Sundry Notices and Reports on Wells

8. Well Name & Number
Grambling #8

It is intended to add pay to the Pictured Cliffs formation and repair the bradenhead in the subject well according to the attached procedure and wellbore diagram.

Grambling #8 Sundry Notice

Grambling #8

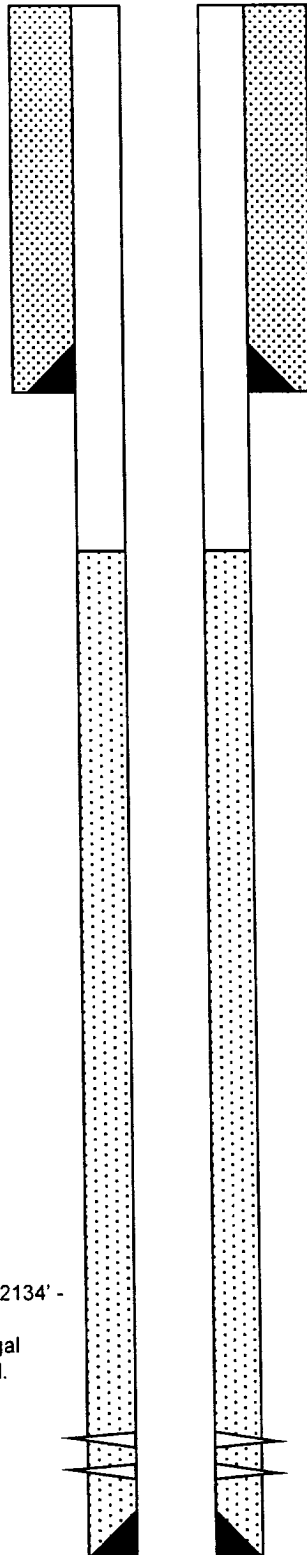
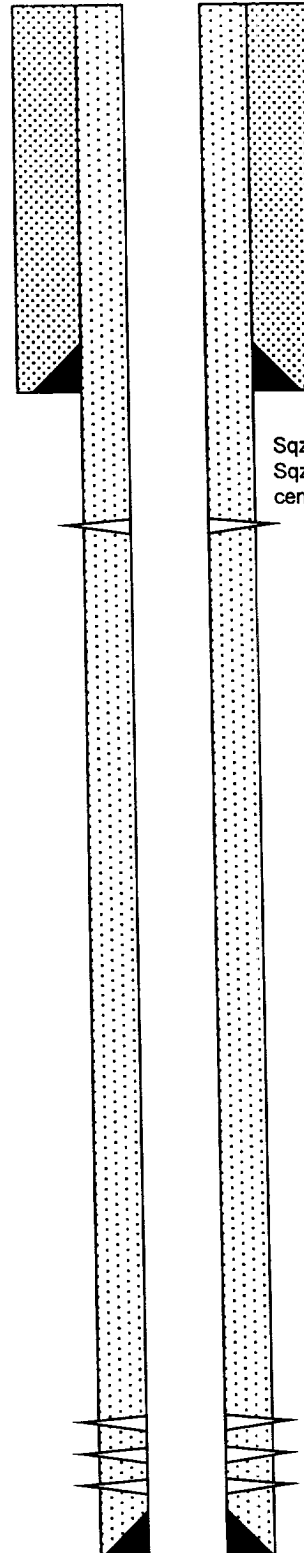
1. Run CBL.
2. Pressure test casing to 4500#.
3. Selectively add perforations within the Pictured Cliffs formation.
4. Fracture stimulate the Pictured Cliffs formation.
5. Set composite bridge plug 50' above top PC perforation.
6. Perforate 2 squeeze holes according to CBL (step 1) to remediate bradenhead failure.
7. Establish circulation. Cement annular volume, circulating Class B neat with 2% CaCl_2 cement to surface. Cement required dependent on CBL (step 1).
8. Drill out cement and composite bridge plug. Clean out well and return to production.

Sqz holes perfed at xxxx'
Sqz'd with xx sxs Class B
cement

Pictured Cliffs: add
perforations and
fracture stimulate with
95Q ClearFrac and
20,000# 12/20 sand
